Intel[®] Mobile Celeron[™] Processor at 466 MHz, 433 MHz, 400 MHz, 366 MHz, 333 MHz, 300 MHz, and 266 MHz Specification Update

Release Date: August 2000

Order Number: 244444-017

Figure 2. Workaround Flowchart: SMBALERT#-Driven System

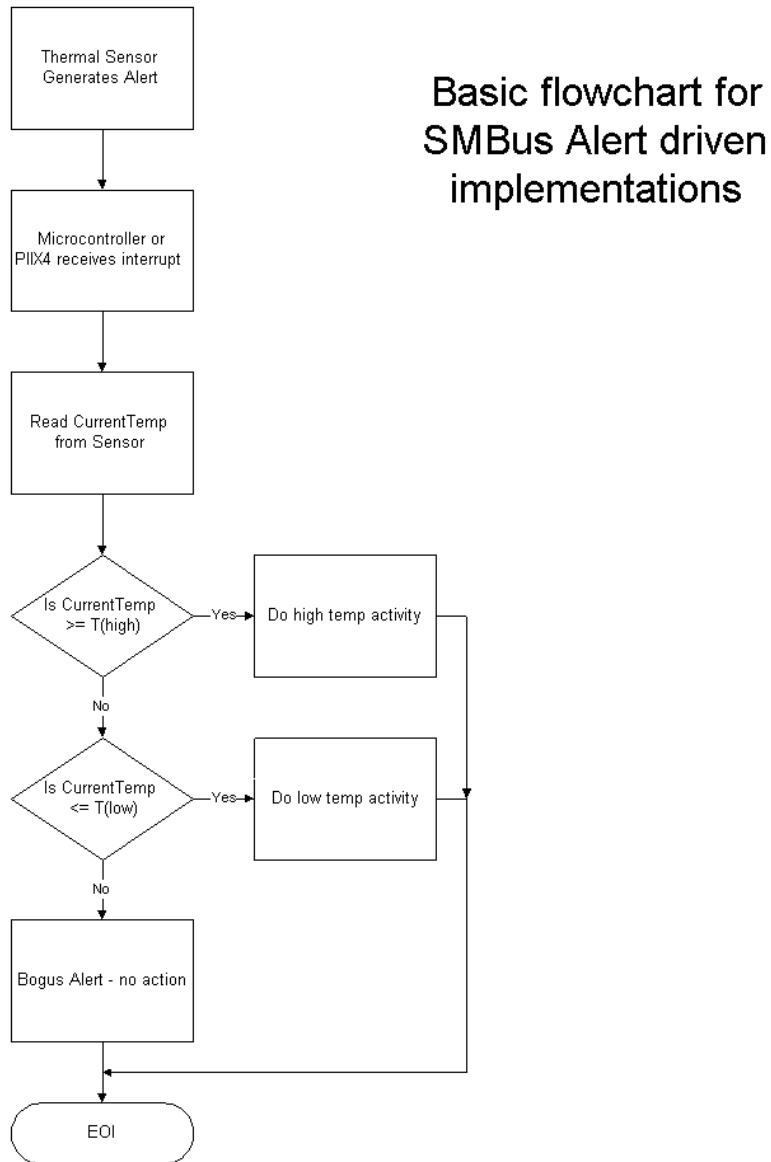
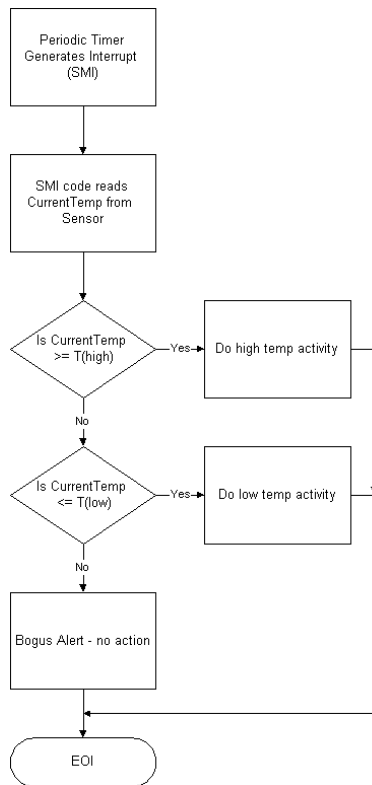
H29. Thermal Sensor May Assert SMBALERT# Incorrectly

Problem: The Intel Celeron Processor Mobile Module has a thermal sensor that monitors the processor core's temperature. Please note that desktop systems could have a similar thermal device. The thermal sensor asserts SMBALERT# if the processor temperature exceeds the temperature limits set in the Alarm Threshold Registers (T_{HIGH}, T_{LOW}). It also sets the corresponding Status Register bits to identify the cause of the interrupt. Figure 1 gives one example of the how the SMBALERT# signal could be used in a system.

Workaround: Three different (mutually exclusive) workarounds are possible:

1. Before servicing an interrupt from the thermal sensor, read and compare the processor thermal reading with the threshold limits (T_{HIGH} or T_{LOW}). Figures 2 and 3 provide basic flowcharts for the implementation of this workaround in an interrupt driven system.
2. If the firmware implemented polls the Status Register only, then before taking any action, re-read the temperature register and do a comparison with the alarm threshold limits (T_{HIGH} or T_{LOW}) to determine if the value is actually still within the temperature window.
3. Use a temperature polling scheme to monitor the processor temperature.

Figure 5.4. Surface-Mount BGA1 Package—Bottom View

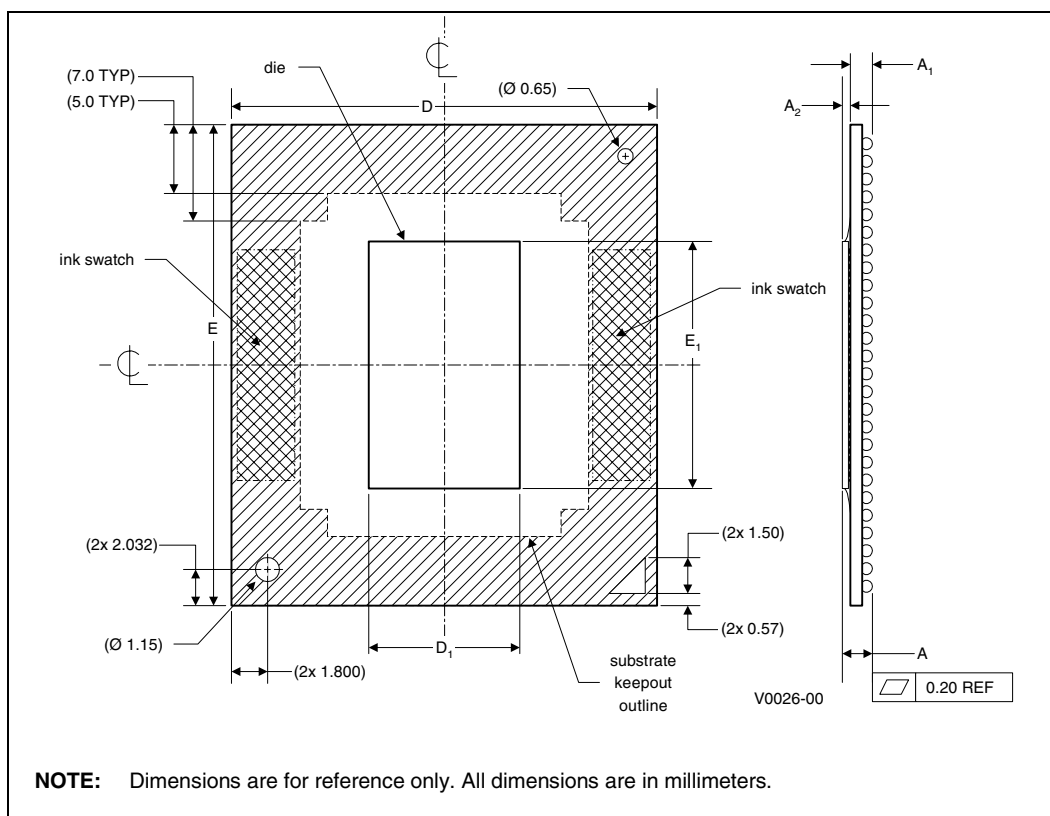
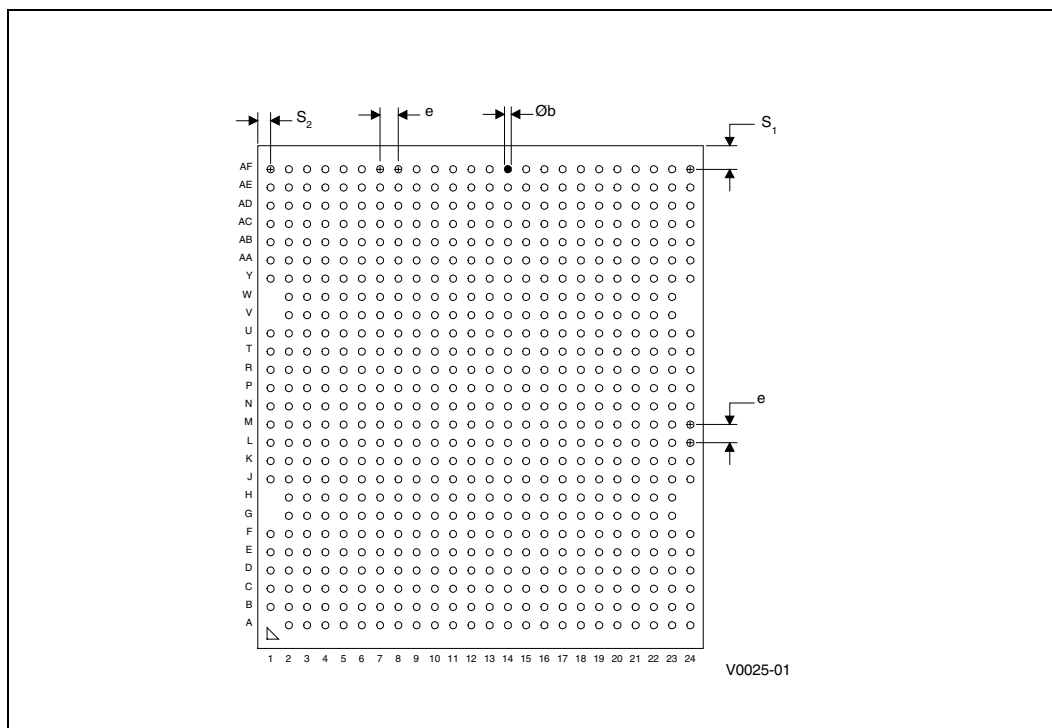
The following table and figures show the updated mechanical specifications for the BGA1 package, listed as Table 5.2, Figure 5.3 and 5.4, respectively, in the *Intel® Mobile Celeron™ Processor in BGA Package at 333 MHz, 300 MHz and 266 MHz* datasheet.

1. The number shown here is different from that in the 244444-004 version of this specification update. The maximum reference number is used.

Figure 3.3 Generic Clock Waveform

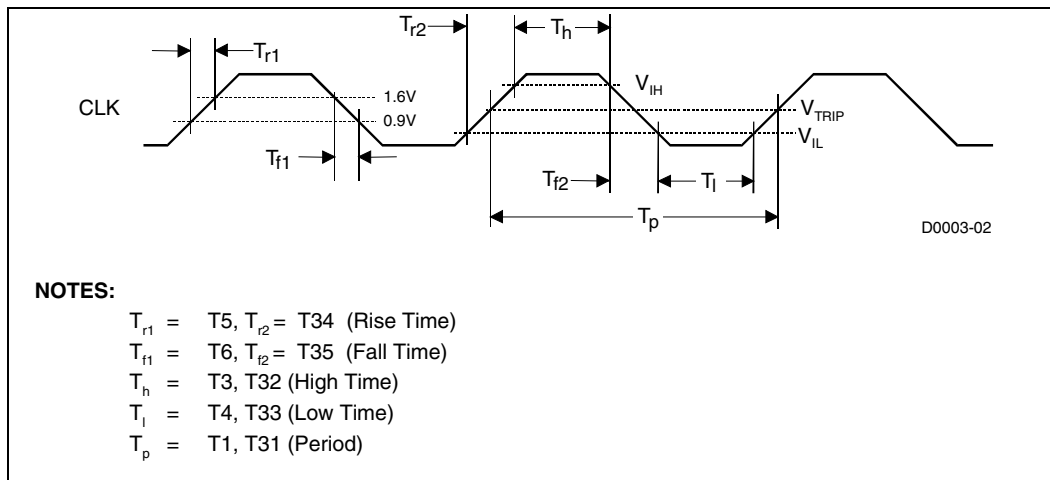
H11. Generic Clock Waveform Figure

Figure 3.3 in the *Intel® Mobile Celeron™ Processor in μ PGA1 and BGA1 Packages at 366 MHz, 333 MHz, 300 MHz, and 266 MHz* datasheet (Order Number 245112-003) has been updated. The following figure is to replace the one in the above document.
